Product Change

Material change M6 extensions (Art. No. 104858, 104859, 104860 and 104861)

2105-01-00

Illustration 1: Extension M6 old version made of brass (Art. No. 104858, Art. No. 104859, Art. No. 104860, Art. No. 104861)

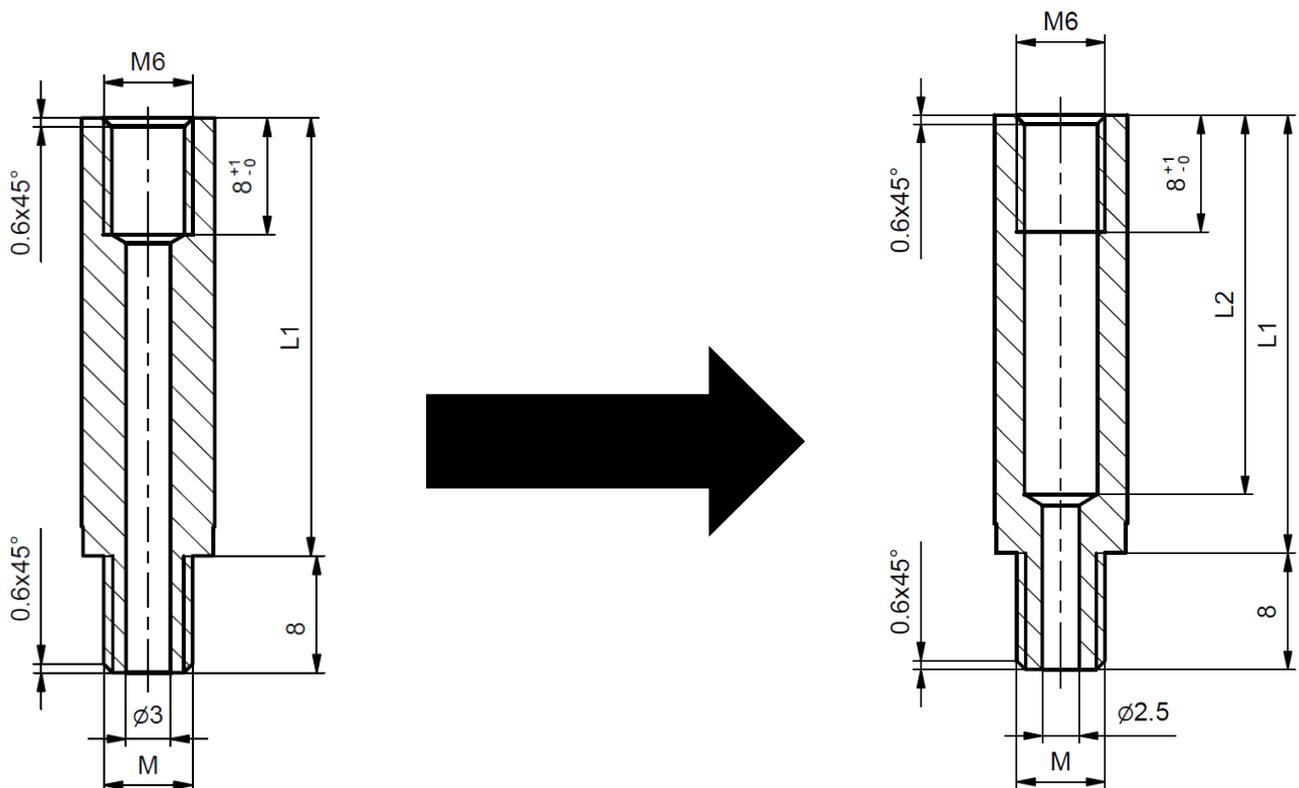
Extensions M6 are changed from brass to stainless steel

The new M6 extensions allow easier assembly and provide increased mechanical strength.

The material is changed from brass to stainless steel.

The outer dimensions of the extensions do not change (see illustrations 1 and 2).

Illustration 2: Extension M6 new version in stainless steel (Art. No. 116291, Art. No. 116292, Art. No. 116293 und Art. No. 116294)
